Project No. **20056**

Project
38 Chester Terrace
NW1 4ND

Drawing Title
Proposed Upper Ground Floor Plan RCP

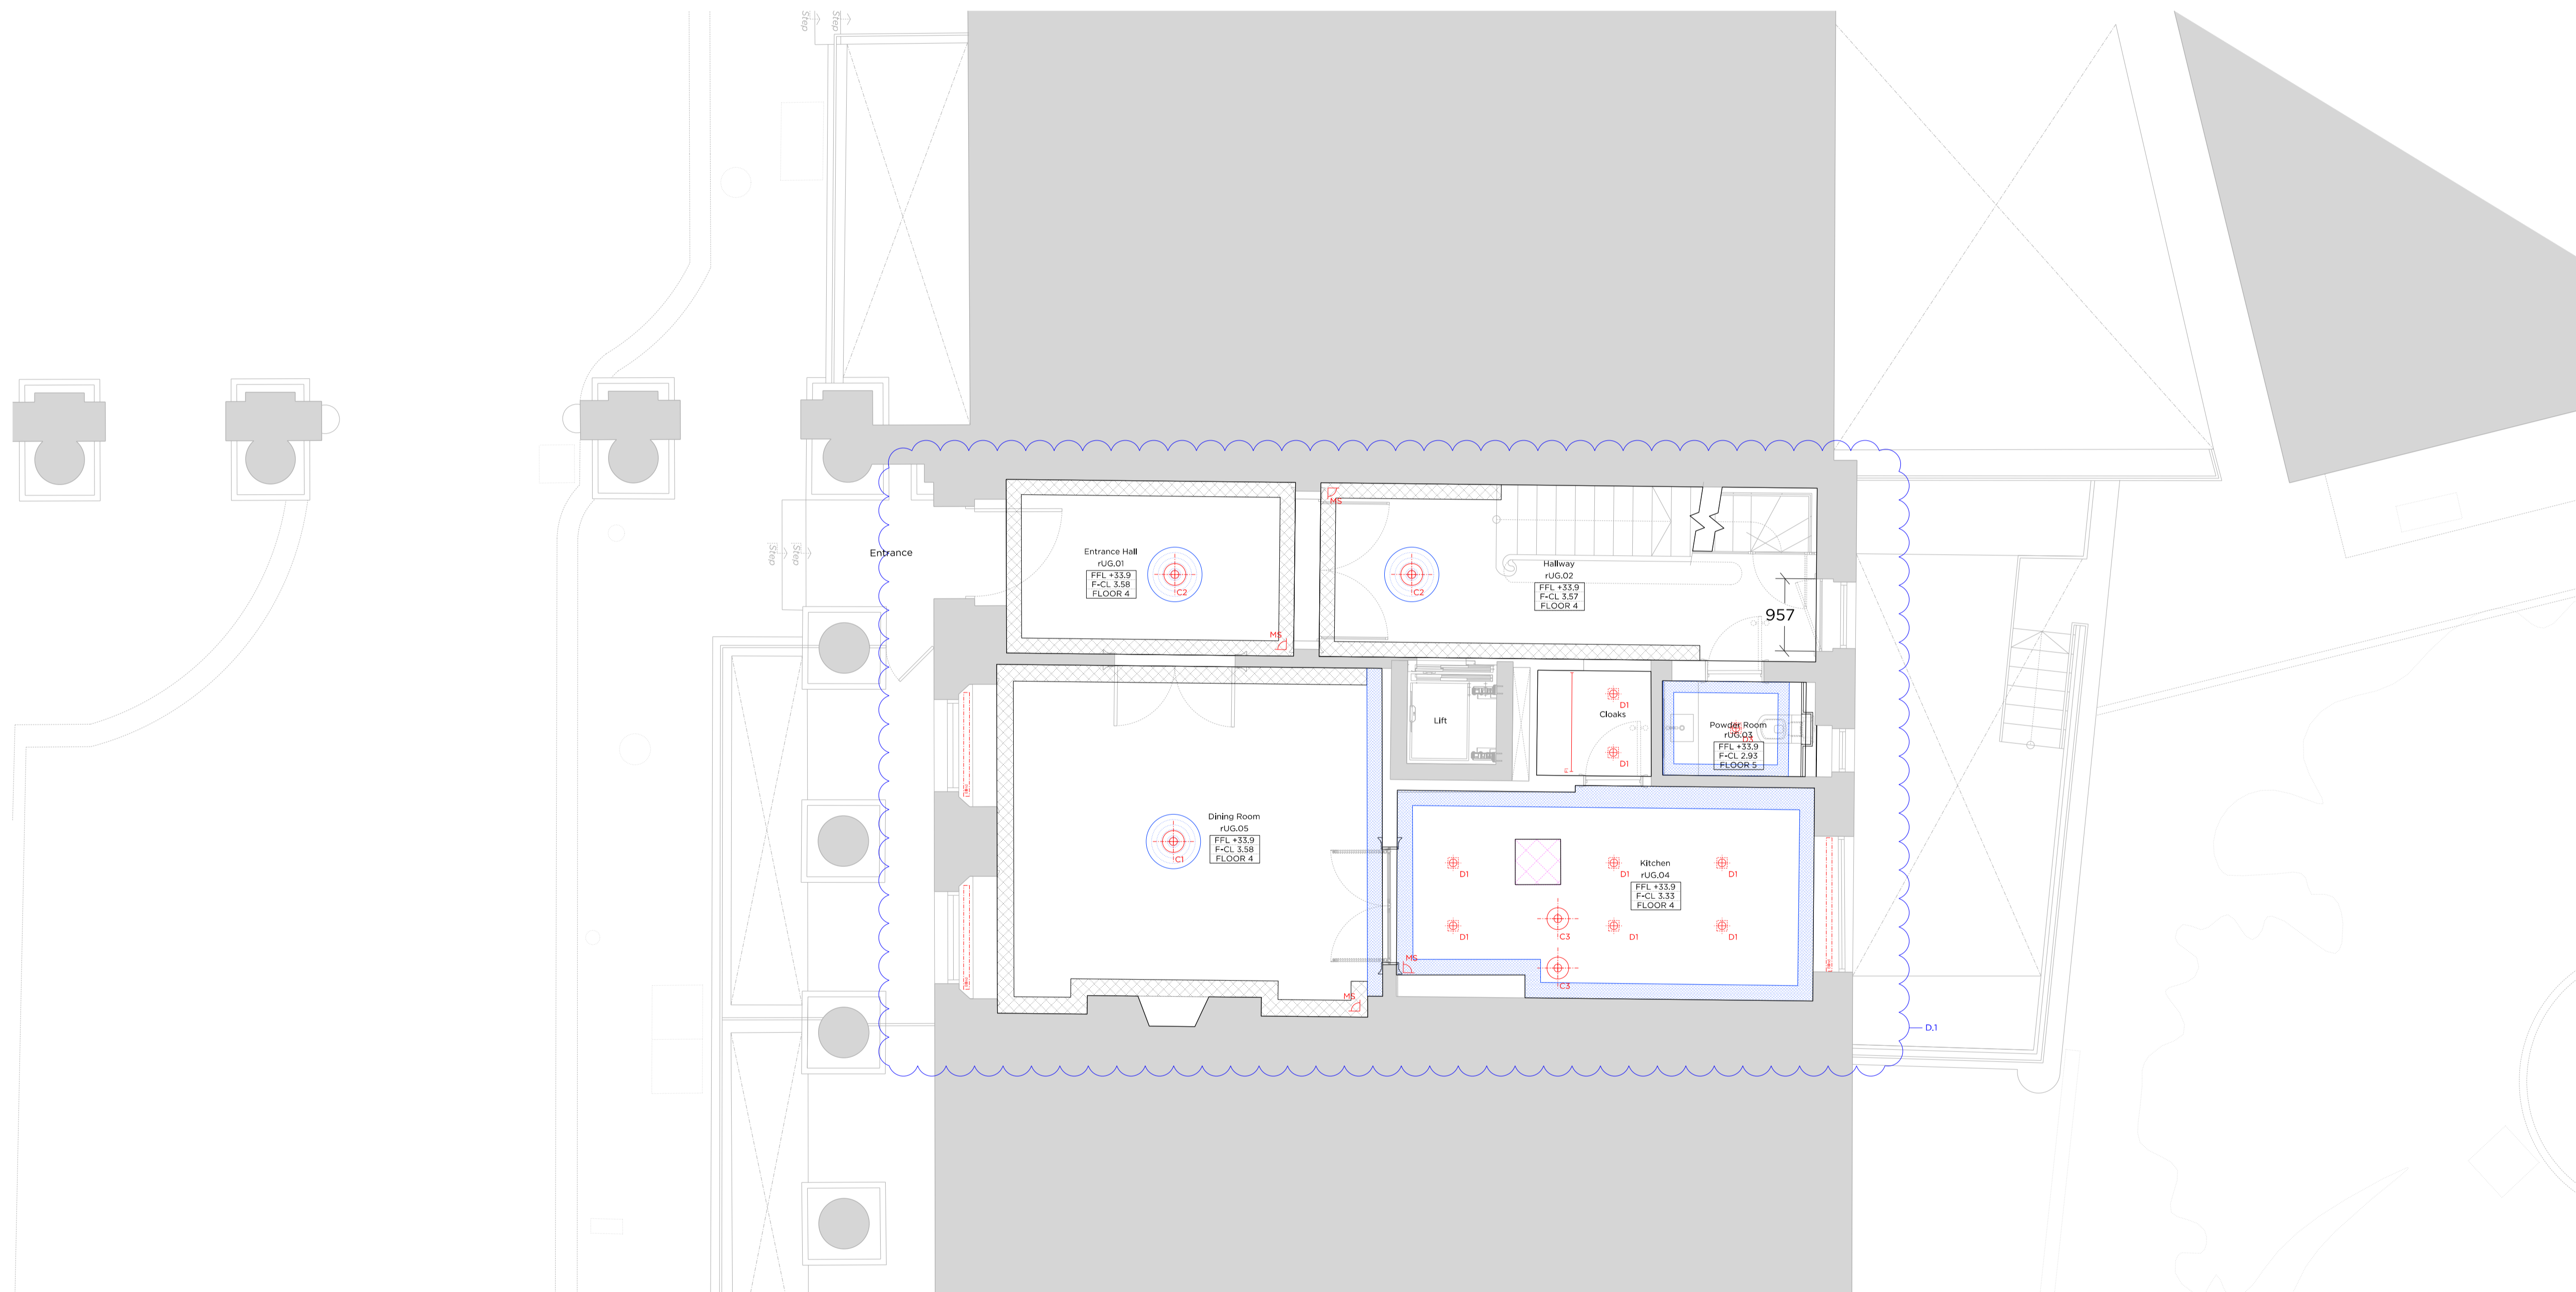
Revision Notes	
Rev. A	29.03.2021
A.1	Existing recessed downlights to be removed from ceilings in principal rooms and ceilings to be patch repaired as per LBC comments.
Rev. B	06.04.2021
B.1	Proposed lighting arrangement amended.
B.2	Coffer ceiling in Kitchen omitted. Cornice added.
B.3	Cornice added in Kitchen and Powder Room.
Rev. C	08.04.2021
C.1	Proposed recessed downlights removed from ceilings in stairhall
Rev. D	03.03.2022
D.1	Coordinated lighting setting out
